# UNITED STATES FUEL COMPANY

Re: Code of Federal Regulations,  
817.121 and 817.126

United States Fuel Company proposes to start a new section in our King IV mine. The new section will be called 8 North and will be driven north off from 11 East. A 1" to 100' scale section map and a quadrangle map with King IV mine overlayed, is included for your convenience. The new section is colored yellow on the quadrangle map.

SUBJECT: Plan Review for Slurry Impoundment No. 1,  
I.D. No. 1211-UT9-0001, King Mine, I.D. No.  
42-00098, Hiawatha, Carbon County, Utah,  
United States Fuel Corporation

SUBMITTED BY MR. BOB ECCLI-US  
FUEL ON 3/15/79. THIS IS THE  
DESIGN DETAIL FOR THE STREAM  
RELOCATION/DIVERSION. — Con

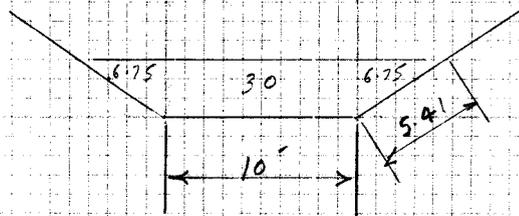
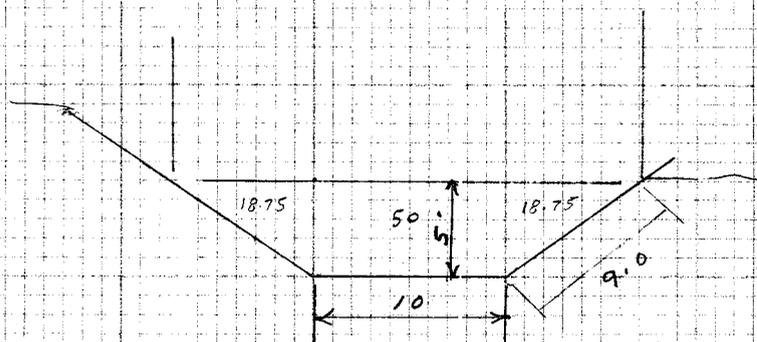
The stream realignment plans call for this structure to be installed as soon as possible so that the dike outslope can be reduced in slope. Mr. Eccli provided the alignment design criteria to the inspectors. Criteria shows the alignment to be capable of passing 2,395 CFS.

U.S. Fuel was instructed that the stream realignment construction could proceed as long as included in the plans are provisions for rip-rapping the channel bottom and stabilizing the side slopes through establishing vegetation on them. The new stream alignment will be designed to follow the same vertical gradient as the original stream bed. In addition, U.S. Fuel was instructed to engage in topsoil conservation techniques in two areas where new construction will take place, the sedimentation pond area and along the stream realignment channel. Topsoil would be stockpiled in a specific area and specified for future use in reclamation procedures. In addition, excess overburden would be stockpiled in a segregated stockpile from the surface soil pile.
